Department of Energy

Subject: U.S. Department of Energy Office of Legacy Management Evaluation of ExxonMobil's License Request to Include the Pit Lake within the Highland, Wyoming, UMTRCA Title II Site Long-Term Surveillance Boundary (Docket No. 40-8102)

**SUPPORTING INFORMATION FOR DOE'S POSITION TO NOT INCLUDE THE
PIT LAKE IN THE HIGHLAND, WYOMING, SITE LONG-TERM
SURVEILLANCE BOUNDARY**

CLIENT		ExxonMobil		
PROJECT		HIGHLAND URANIUM PROJECT ACL APPLICATION		
TITLE		CROSS-SECTION B-B' CURRENT CONDITIONS		
 amec EARTH AND ENVIRONMENTAL	DRAWN BY	JKM	CHECKED BY	BW
	FILENAME	877520022	DATE	4/28/11
	FIGURE No. 1-10

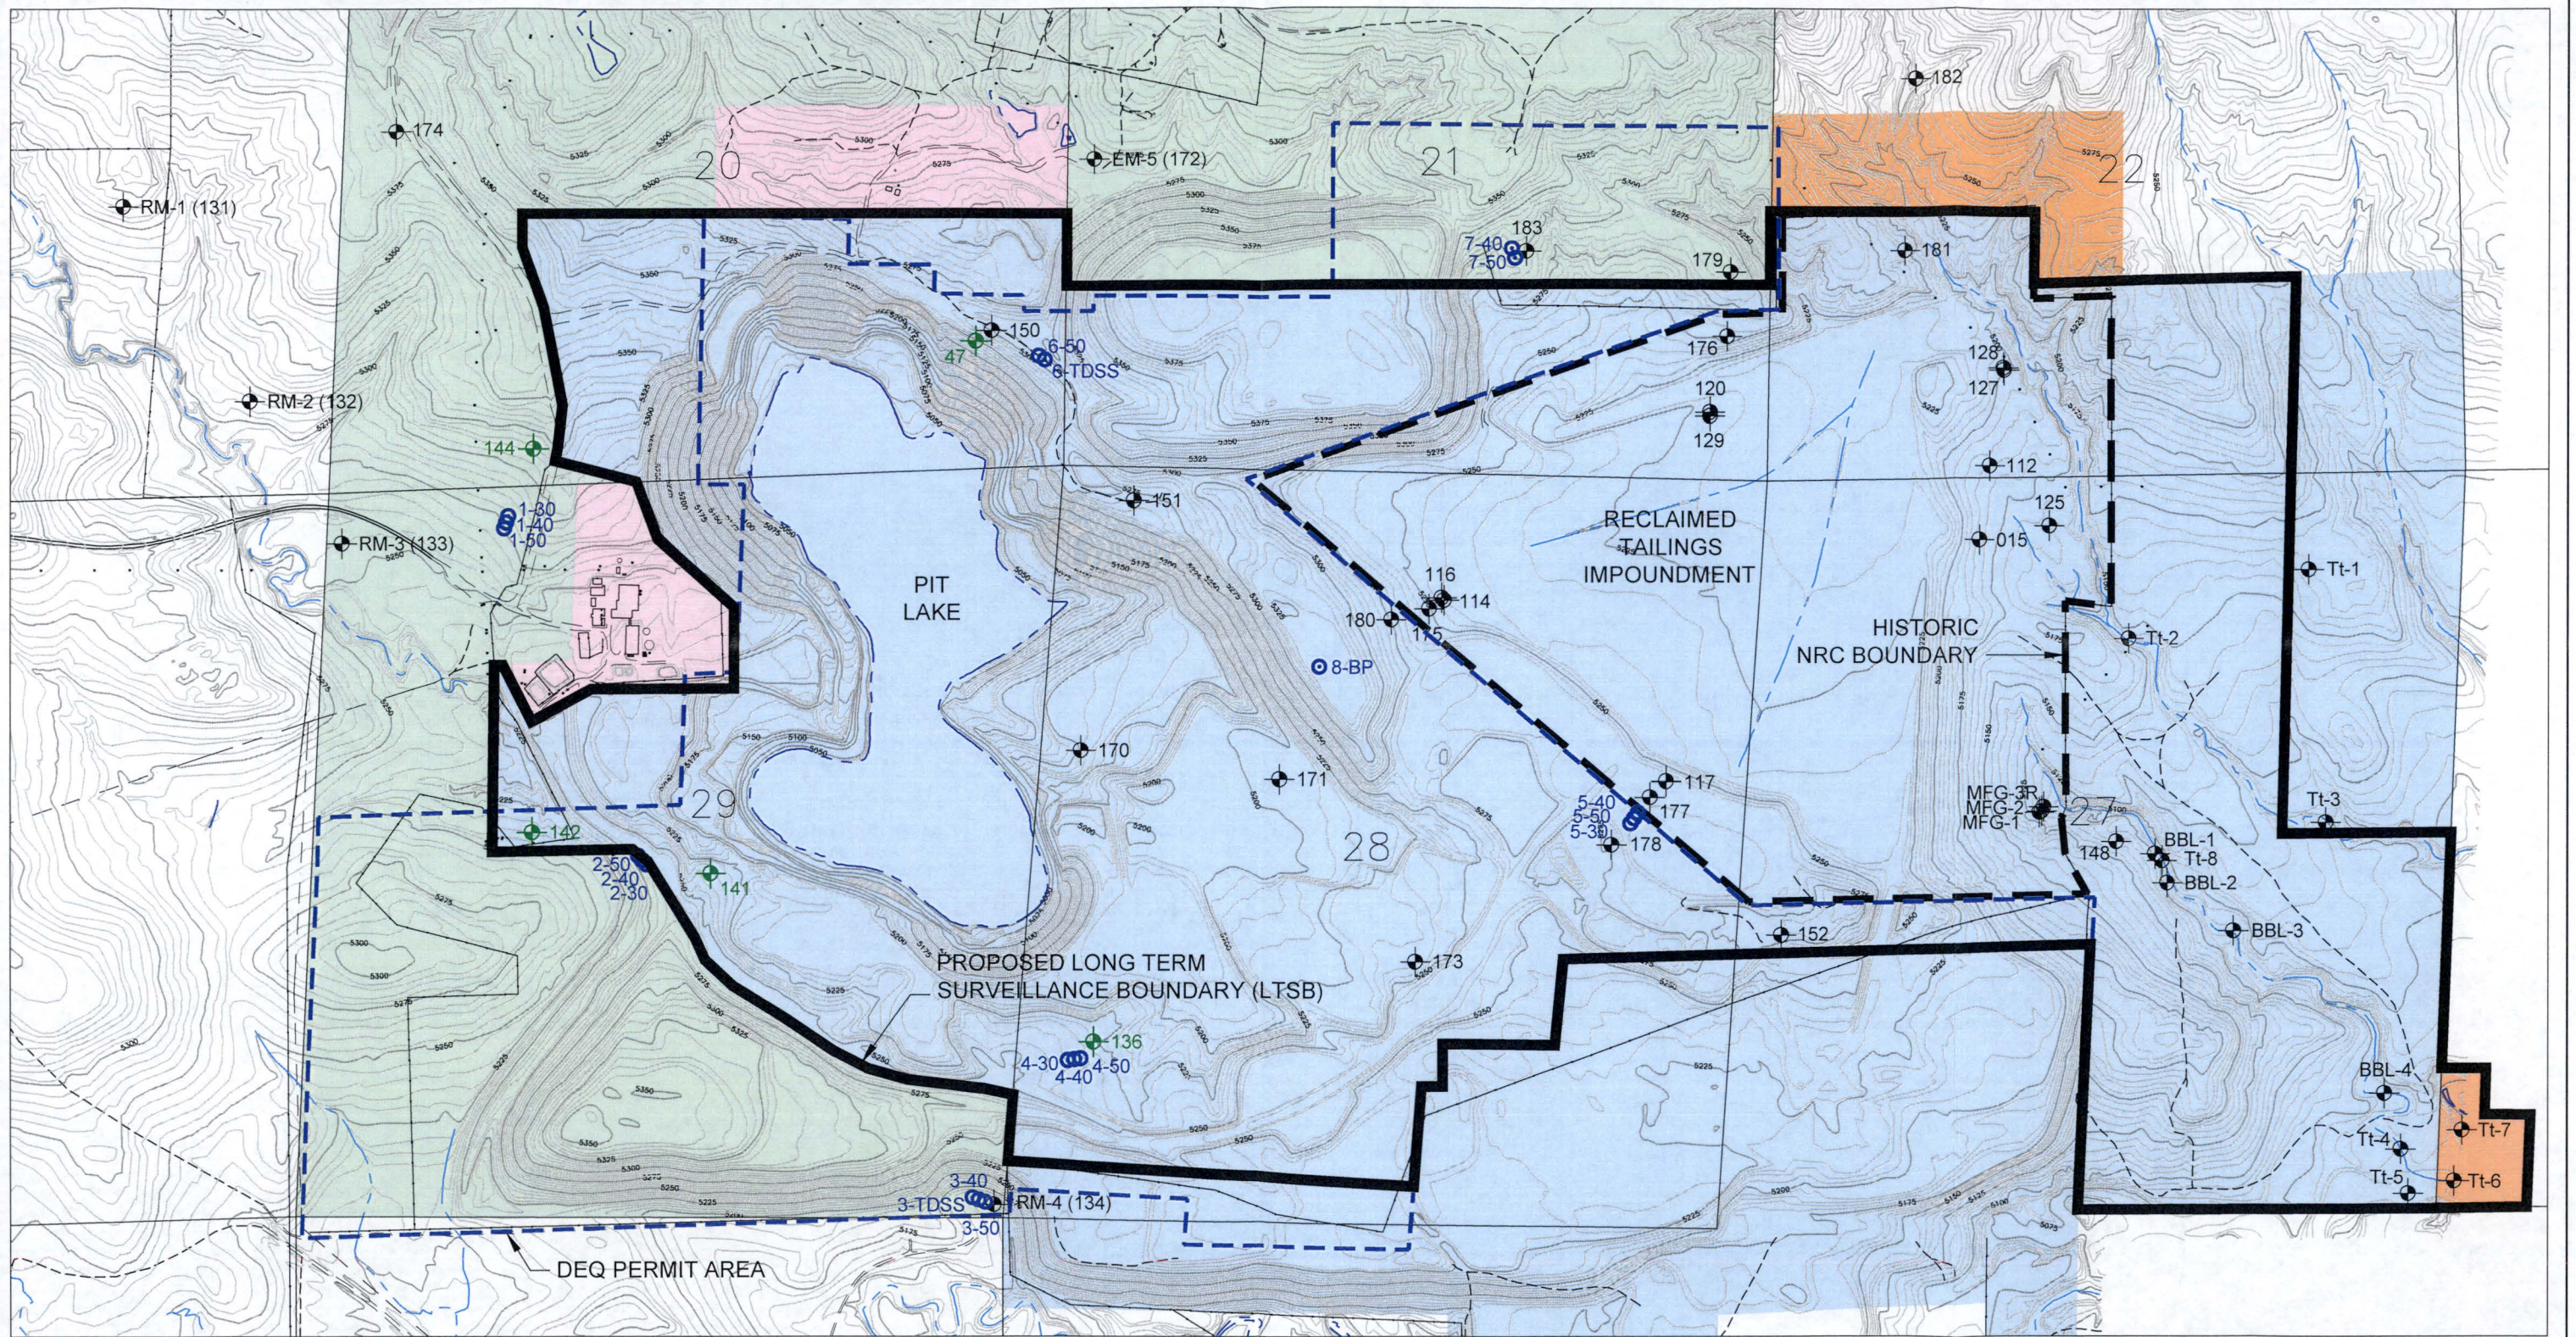
- The licensee's geochemical argument is conceptual in nature—there are no actual modeling or monitoring data to support conservative transport of uranium under conditions that exist(ed) at the Highland site. The licensee states that the transport of uranium through the Tailings Dam Sandstone (TDSS) (shown on enclosed cross section Figure 1-10) occurred before groundwater monitoring was conducted.

- End members for mixing calculations were selected to maximize the potential contribution from seepage. The evaluation makes the assumption that much of the chloride in the lake is from tailings seepage even though concentrations are similar to those in Ore Body Sandstone (OBSS; labeled as 30-, 40-, and 50-Sandstone on enclosed cross section) groundwater based on monitoring data; in other words, all chloride in the pit lake could come from the OBSS based on concentrations observed in monitoring wells.

- The TDSS was only in contact with the tailings pond in the eastern half of the impoundment (EPRC 1982). This means that any tailings pond seepage into the TDSS would need to migrate nearly a mile before discharging to the pit lake (see enclosed site map [Figure 1-2] and cross section [Figures 1-10]). In addition, backfilled former open pit uranium mines lie between the tailings impoundment and the pit lake, so seepage would need to migrate through this backfill material before entering the lake. A review of

FIGURE 1-2
 HIGHLAND SITE PROPOSED LONG TERM
 SURVEILLANCE BOUNDARY

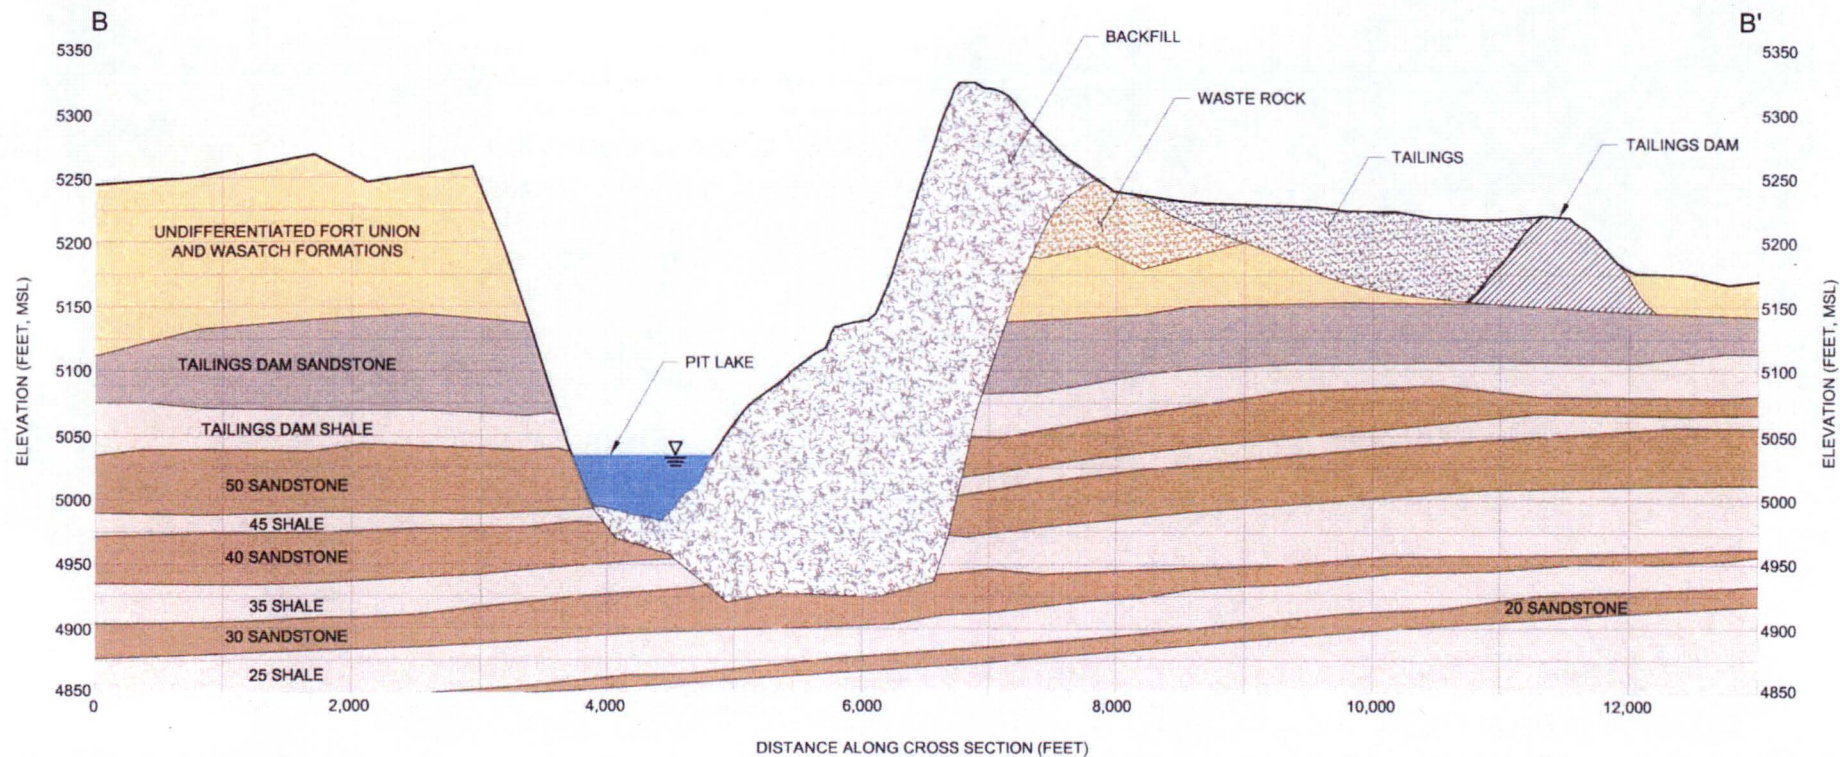
the 1982 pit lake hydrology report done on behalf of NRC indicated that the backfill material likely acted as a barrier for migration of groundwater from the TDSS to the pit lake (WRA 1982). Consequently, tailings pond seepage was predicted to move to the northwest and southwest rather than directly west to the pit lake. This would further increase the distance that tailings seepage would need to move before entering the pit lake. Based on DOE's experience at numerous other sites, the licensee's conceptual model of high concentration tailings seepage entering the pit lake appears to be unlikely.
